## Report to the Future Melbourne (Planning) Committee

## Ministerial Referral: TPD-2012-32/A, 731-739 Flinders Street, Docklands

# PLANNING PERMIT AMENDMENT - DISCUSSION PLAN

# DELEGATED PLANNING APPLICATION REPORT

Figure 16. elevation indicating some of the changes from the approved to the proposed building envelope

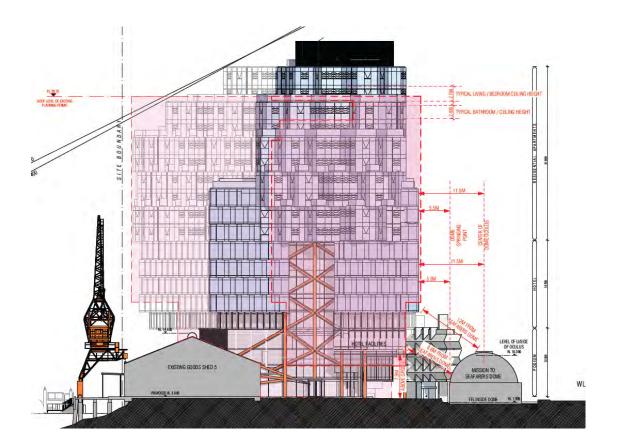
The podium height and setbacks of the proposed building have been modified but are generally the same configuration as the approved building envelope as demonstrated in Figure 16 above. The building envelope does not increase any non-compliance in relation to the proposed podium height and setbacks.

Figure 17. Lower levels approved and proposed building footprint

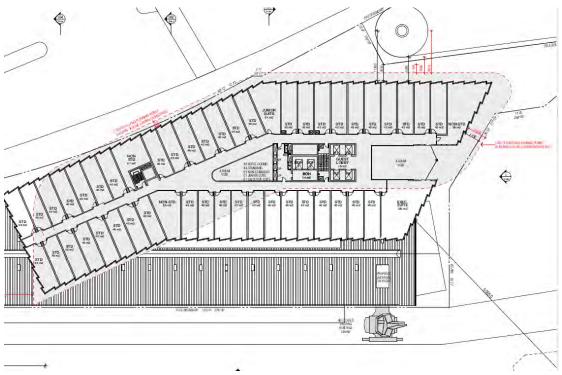
The new building is proposed to be 17 levels, a total height of 63.5 metres (excluding roof plant) and generally straddles part of the historic Goods Shed building.
